From: Davis, Eva [Davis.Eva@epa.gov]
Sent: 11/12/2015 9:48:37 PM
To: d'Almeida, Carolyn K. [dAlmeida.Carolyn@epa.gov]; Wayne Miller [Miller.Wayne@azdeq.gov]
CC: Dan Pope [DPope@css-dynamac.com]
Subject: RE: 2015-11-10 - wafb - FYI - UXO Pro-Praxis comments - ST012 - Steam Injection termination criteria not met

From: Steve Willis [mailto:steve@uxopro.com]
Sent: Tuesday, November 10, 2015 2:54 PM
To: Wayne Miller <Miller.Wayne@azdeq.gov>
Cc: Bo Stewart <bo@praxis-enviro.com>
Subject: 2015-11-10 - wafb - UXO Pro-Praxis comments - ST012 - Steam Injection termination criteria not met

Our comments on EPA's evaluation of the SEE shutdown criteria are as follows:

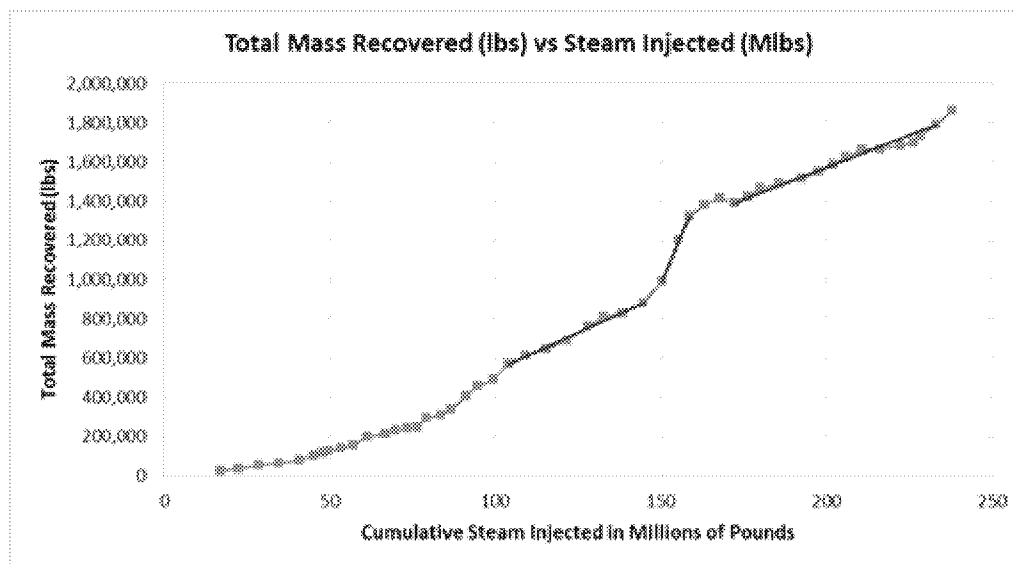
- Subsurface Temperature (Secondary): The thermocouples utilized in calculating zone averages have changed over time and many readings have proven to be unreliable. Attainment of this secondary criterion is inconclusive.
- Completion of Pressure Cycling (Secondary): Increases or decreases in vapor concentrations associated with pressure cycling are not evident in the data presented. Attainment of this secondary criterion is inconclusive.
- Mass Removal (Primary): Mass removal rates remain well above 10% of approximate peak rates. Significant declines in mass recovery rates are not evident in recent data. Attainment of this primary criterion has not been achieved.

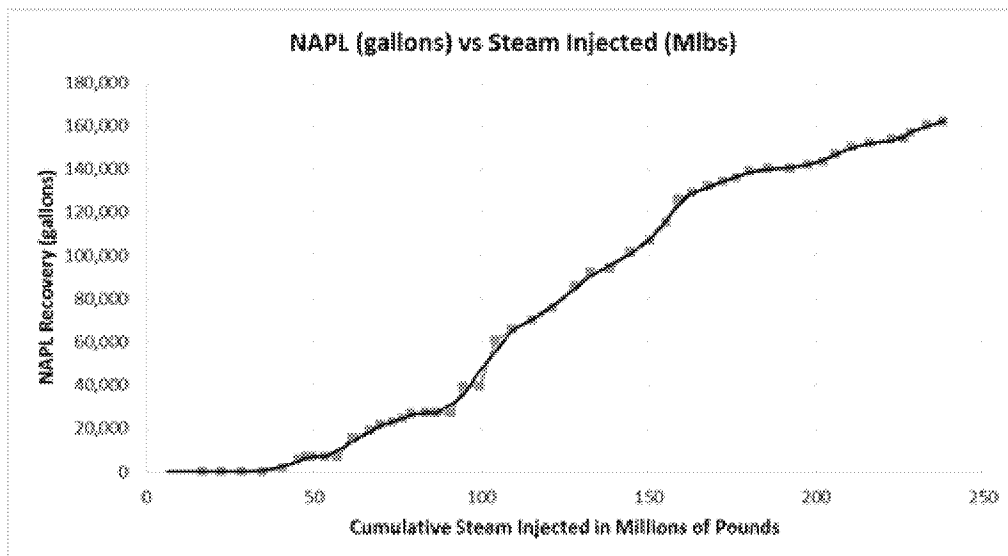
- **Benzene Concentrations (Primary):** Benzene concentrations remain elevated and above initial values at many locations based on the Weekly Progress Reports. In addition, the current methodology for assessing benzene concentrations is indirect and unreliable. Attainment of this primary criterion has not been achieved.
- **Steam Injection (Guideline):** The targeted total steam injection has not been achieved.

The cumulative mass removal plotted in Figure 3 of the Weekly Reports shows an inflection point for a decrease in the rate of mass recovery around June 20th coinciding with the initiation of de-pressurization in the LSZ. The inability to assess mass removal from individual treatment intervals (CZ, UWBZ, LSZ) hampers the evaluation of performance.

The total mass recovery is plotted below as a function of cumulative steam injected instead of date. Steam breakthrough in a number of wells may coincide with the jump in mass recovered between the cumulative steam injection of 150 to 160 Mlbs. However, the rate of mass recovery, illustrated by the slope of the red line, is similar in value before and after the jump in mass recovery. The data do not indicate a significant decay in recovery rate after breakthrough. Similarly, the NAPL recovery alone is also plotted as a function of cumulative steam injected instead of date. The NAPL recovery rate remains relatively steady from 160 million pounds of steam and beyond.
